Exhibit 3 - Preliminary Modifications at Clement / Stanton

Exhibit 3 Item 6-C
Transportation Commission Meeting
July 22, 2026

Clement Ave at Stanton St
lane shift

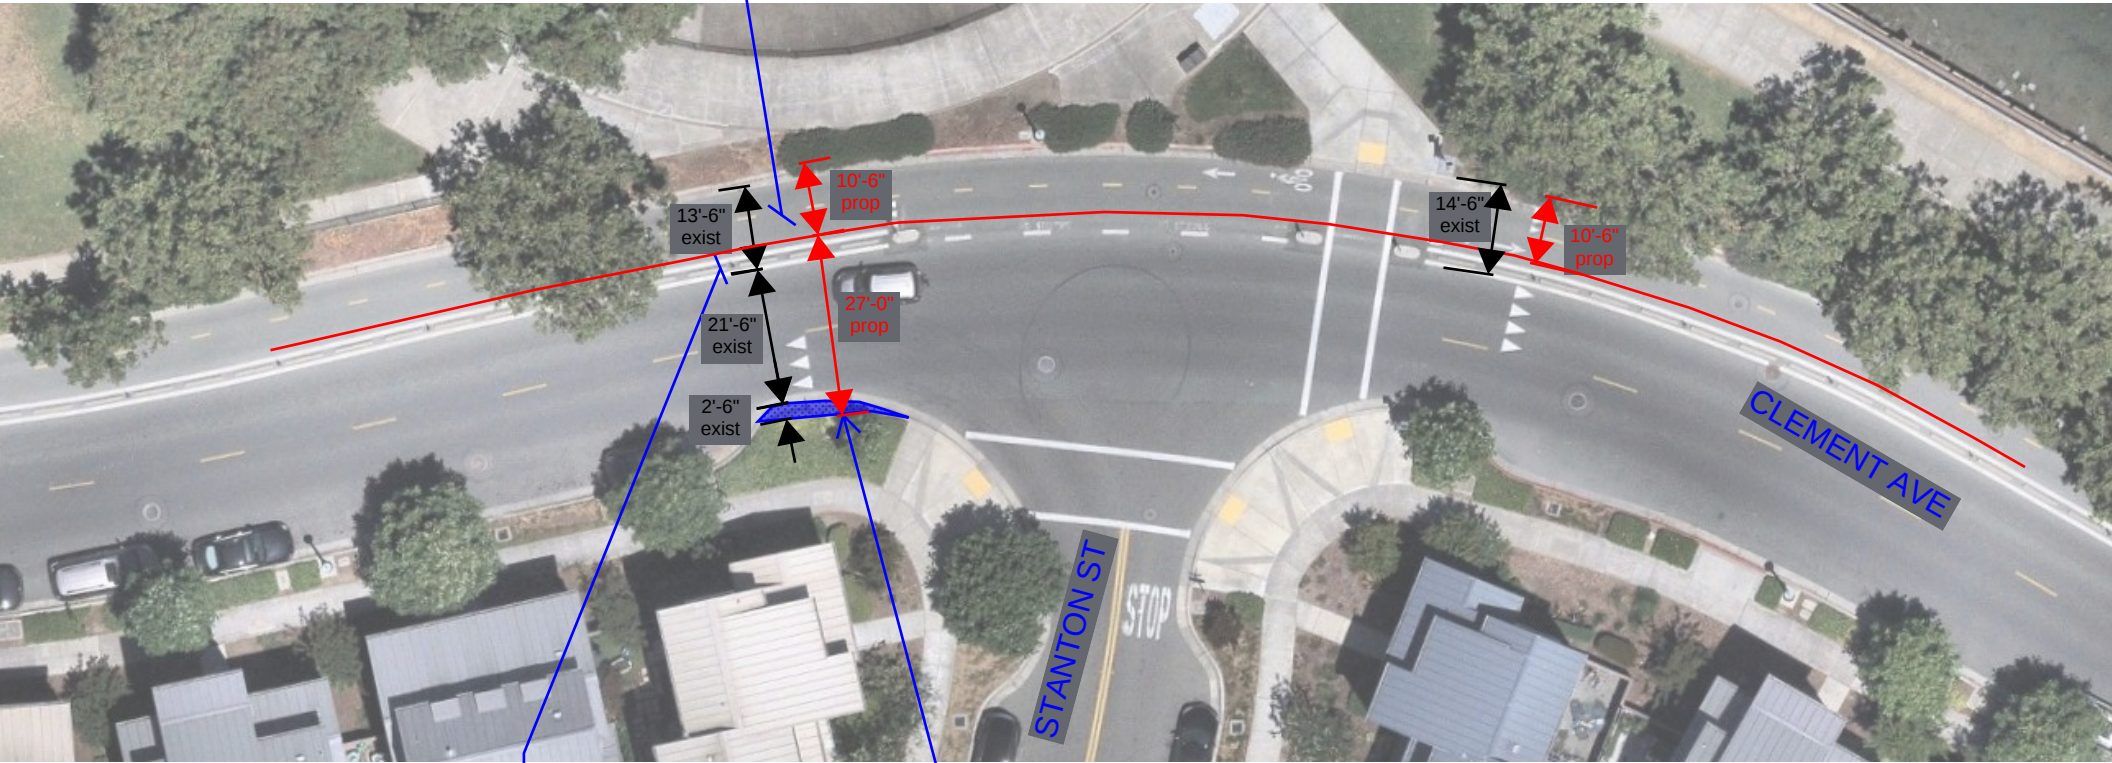
reduce the cycletrack width as much as possible (within standard).

remove and relocate concrete buffer between cycle track and vehicle lane (maintain 2'-0" width)

trim bulb-out
